C30 CLUTCH REPLACEMENT

The purpose of this TI document is to inform that the original type clutch is discontinued and no longer available, the new type clutch is an identical fit.

Machine Effective Dates: C30HDZ – June 2012, C30HDG – October 2012

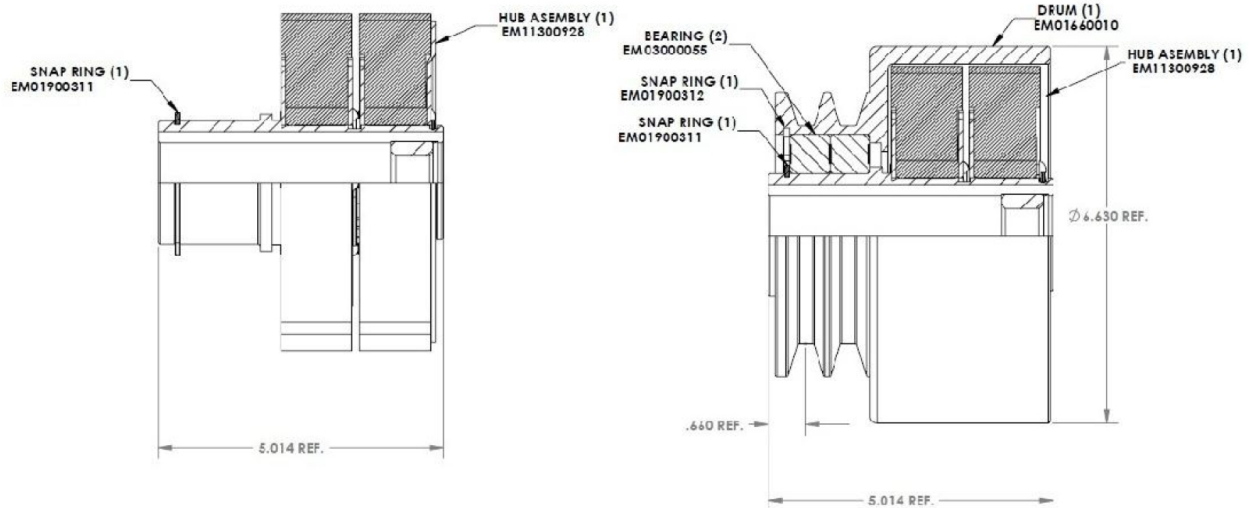
DISCONTINUED CLUTCH
MQ Part # EM14320

NEW REPLACEMENT CLUTCH
MQ Part # EM14351

IMPORTANT: When changing over to the new replacement clutch, the retainer bolt must be replaced.

NEW RETAINER BOLT
MQ Part # EM963105
(HHCS • ½ -13x2 inch • G5)

NEW LOCK WASHER
MQ Part # EM923346
(½ inch)

A new Key and Washer is supplied with new replacement clutch

CLUTCH ASSY

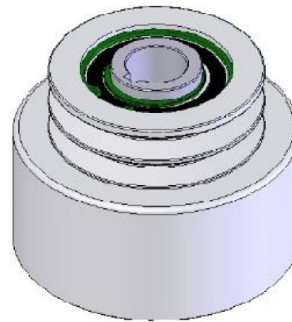
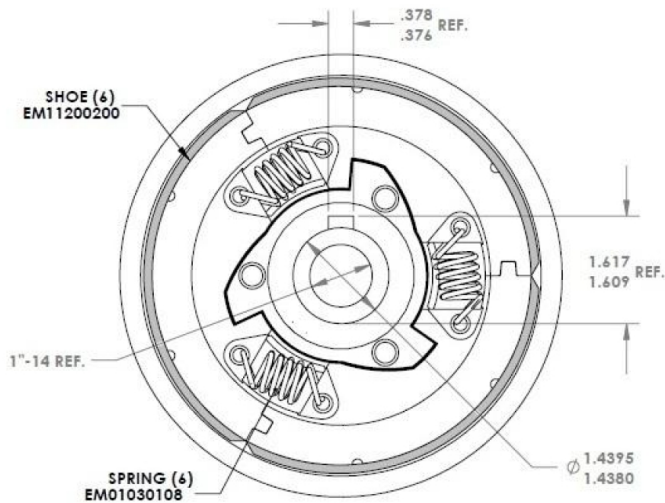
NOTE: EM02500036 KEY TO BE SUPPLIED WITH EACH CLUTCH ASSEMBLY

WASHER (1)
EM02400134
(SUPPLIED WITH CLUTCH)
